**RE: Amendment Application for the Witberg Wind Energy Facility DEA ref. 12/12/20/1966/AM6**

This statement letter is in reference to the authorized Witberg Wind Energy Facility (WEF) and the request by Savannah Environmental for comment on the ecological implications of the proposed changes to the layout and turbine specifications that would be included in the Amendment. Witberg Wind Power (Pty) Ltd is proposing to amend the EA as follows:

**Figure 1.** The ecological sensitivity map of the Witberg site and the 25-turbine layout as provided for the current assessment.

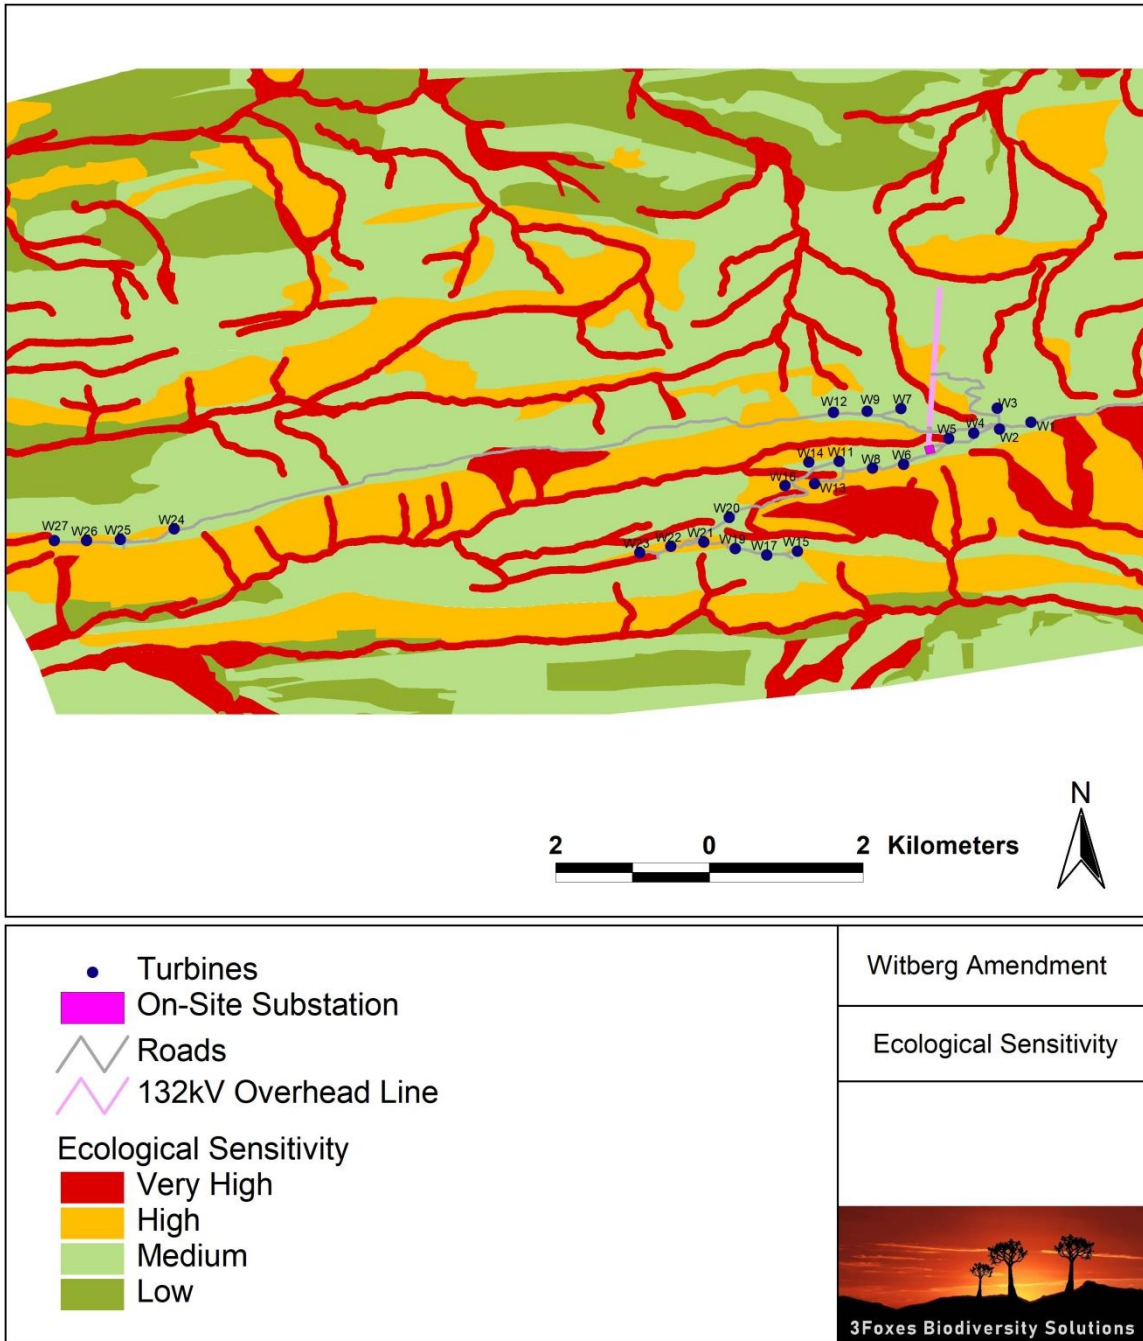
I have reviewed the amended layout in reference to both the previously amended and approved layout as well as the ecological sensitivity of the site. The previous layout consisted of 27 turbines while the current proposed amended layout this has been reduced to 25 turbines. The amendment includes increasing the size and output of the turbines and in terms of impacts on terrestrial ecology, this would not be likely to generate any additional impacts or noticeably increase any previously assessed impacts. The increase in the size of the turbines is offset by the reduction in the number of turbines. As such, **the change in the turbine number and specifications is not considered to have material additional or reduced impact on terrestrial ecology** and as such, no changes to the previously assessed impacts are recommended as a result of the changes to the turbines.

The amendment includes some changes to the layout including the repositioning of some of the turbines. While the majority of turbines are in close proximity to their original positions, with minimal potential change in impact, three turbines have been lost from the east of the site and repositioned on ridges to the west. The revised positions have been interrogated and found to be within acceptable positions where their impact is likely to be similar as the previous positions and no additional impact can be anticipated as a result of the changes. Consequently, there is no change to the assessed impacts as a result of the change in turbine positions. The additional changes to the layout such as access roads, power line, construction camp and substation position, have also been reviewed and no changes to the impact of the development on terrestrial ecological features were found to have occurred. As such, it is concluded that the change to the layout of the development has not had an impact on the previously assessed impacts associated with the development.

Although, no additional impacts are likely to occur as a result of the amendment, it should be noted that the effected environment is considered sensitive and a variety of plant species of high conservation concern are known from the immediate area. As previously noted and reiterated here, the need for a pre-construction walk-through of the entire development footprint with local adjustment to the routing of access roads and micro-siting of turbines where deemed necessary should occur should the development proceed to construction. A pre-construction walk-through of the facility would also be required in order to comply with the permit conditions for the development as a variety of protected species may be impacted and a permit from CapeNature would thus be required.

- The findings of this statement are contingent on the layout as provided for the assessment. There are a variety of sensitive and threatened species at the site which are vulnerable to impact and which can be affected by changes to the development layout.
- Should the development proceed to construction, the final development footprint should be subject to a pre-construction walk-through to inform the final placement of roads and turbines as well as locate and identify species of conservation concern that are within the development footprint. Some search and rescue of plant species of conservation concern may be required.
- The Witberg Amended layout is supported in terms of terrestrial ecology impacts as it will not result in an increase in the significance in any of the assessed ecological impacts and is not considered substantially different from the previous 27 turbine layout.
